# Explanation of Significant Differences for the Record of Decision for the Test Area North Operable Unit 1-10

At the Idaho National Engineering and Environmental Laboratory  
Idaho Falls, Idaho

**DOE/NE-ID-11199**  
**Revision 0**  
**Project No. 23093**

**January 2005**

Figure 3. Location of V-Tanks Sites TSF-09/18 and PM-2A Tanks Site TSF-26.

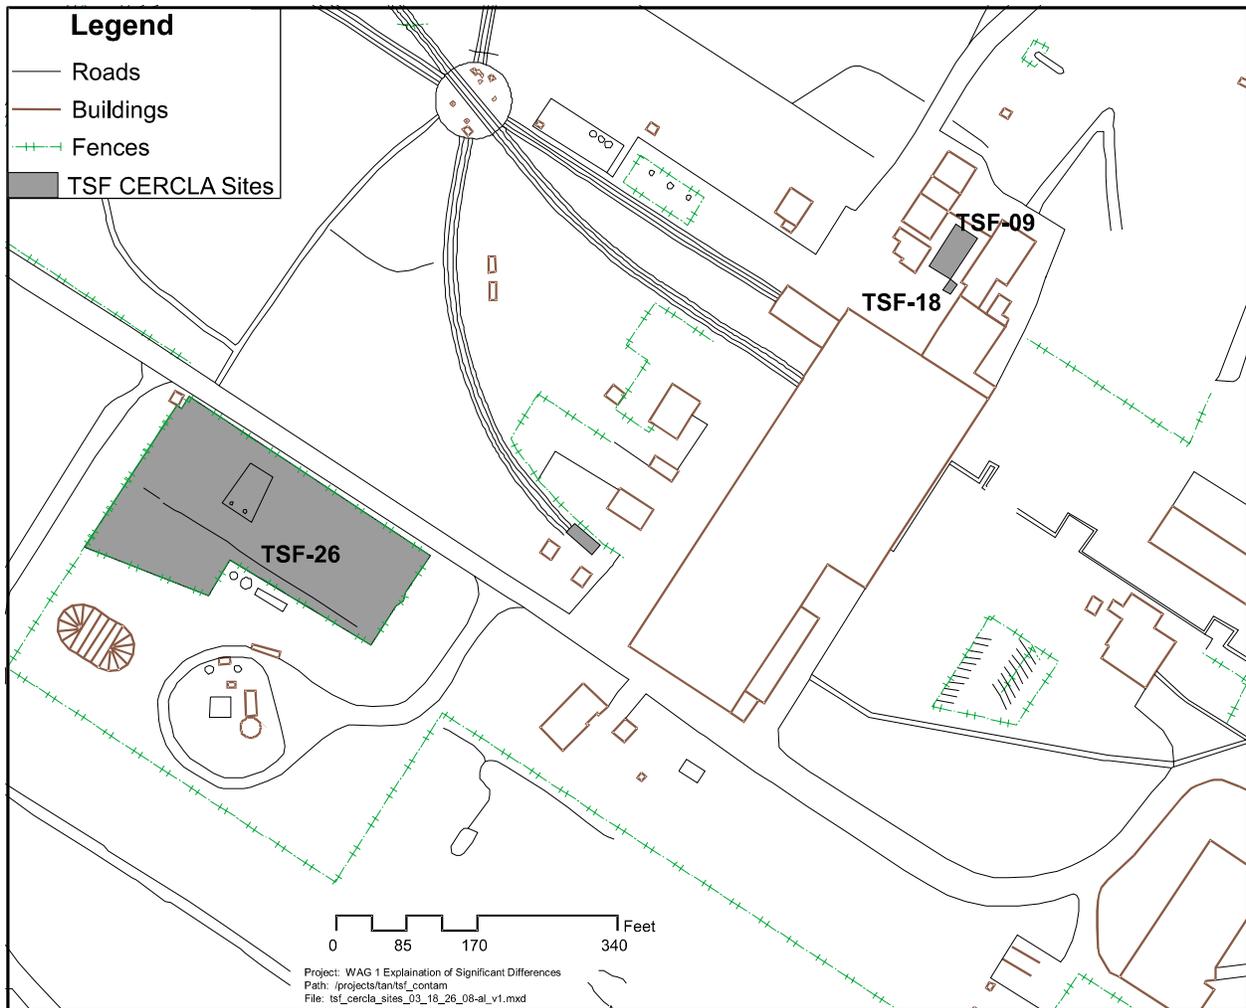
The TSF-26 area included the two PM-2A Tanks and surrounding area (see Figure 3). Remediation of the surrounding area was completed in September 2004. The two underground tanks were excavated and moved into the TAN-607A high bay for temporary storage in June 2004. These two tanks (Tanks V-13 and V-14) are each 55 ft long and 12.5 ft in diameter. Each tank has a capacity of 50,000 gal. Each tank contains approximately two feet of sludge and diatomaceous earth (approximately 5000 gal or 45,000 lb each). Waste from the V-Tanks (discussed above) was routinely moved to the PM-2A Tanks by pipeline or tanker truck until the early 1970s. Most of the waste from the V-Tanks was processed through an evaporator before transport to the PM-2A Tanks. Normal industrial means were

Figure 4. Location of TSF-46, 47, and 48 new sites and TSF-19 Caustic Storage Tank.

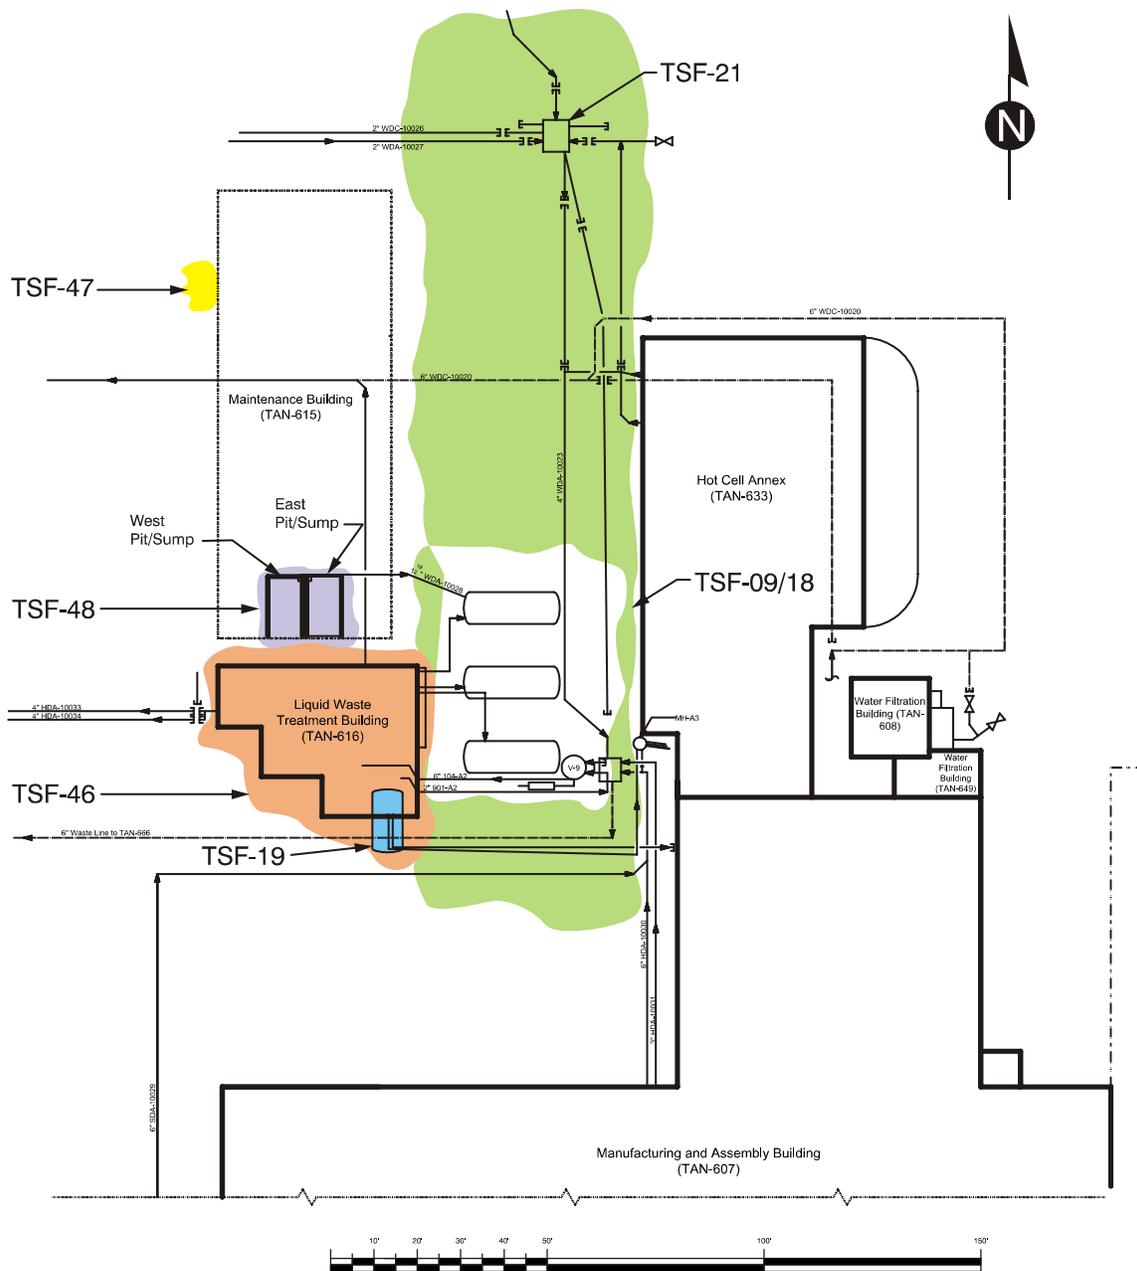
TSF-46, 47, and 48 (see Figure 4) were identified in conjunction with the removal of buildings TAN-615 and 616. Contamination at these sites is presumed to be a result of the waste handling activities associated with these two building. TSF-46 consists of the soils surrounding and between the former location of building TAN-616. TSF-47 consists of the soils surrounding a broken pipe adjacent to the former location of TAN-615. TSF-48 consists of the soils beneath the sump location in the former building TAN-615. These three sites are adjacent to the TSF-09/18 site.

TSF-19 (see Figure 4) is located within the new site identified as TSF-46. This caustic tank was a feed tank for providing caustic to neutralize the waste in the V-Tanks. The unit ceased operation when the V-Tanks ceased operation in the late 1970s. Initial investigations in the 1990s indicated that the tank was empty. The OU 1-10 ROD in 1999 identified TSF-19 as a No Action site.

Further investigation as part of the removal of TAN-616 and the TSF-46 new site revealed that the TSF-19 caustic tank was not empty and that some radioactive contamination was present. A recent video inspection of the inside of the tank revealed a significant heel still present. As a result of finding waste still present within TSF-19, the status of the tank and surrounding soils will be changed from No Action to remediation required in conjunction and consistent with the TSF-46 site that surrounds the TSF-19 caustic tank. The tank and contents will be removed, treated as necessary, and shipped to ICDF or another approved disposal facility. The surrounding soils will be addressed as part of TSF-46. (see Table 4)

Remedial Action Element	Original/Changed Remedy	Remedy Change
Tank Remediation	No Action	Remove tank and contents. Dispose at ICDF or other appropriate facility. Soils are addressed as part of TSF-46.
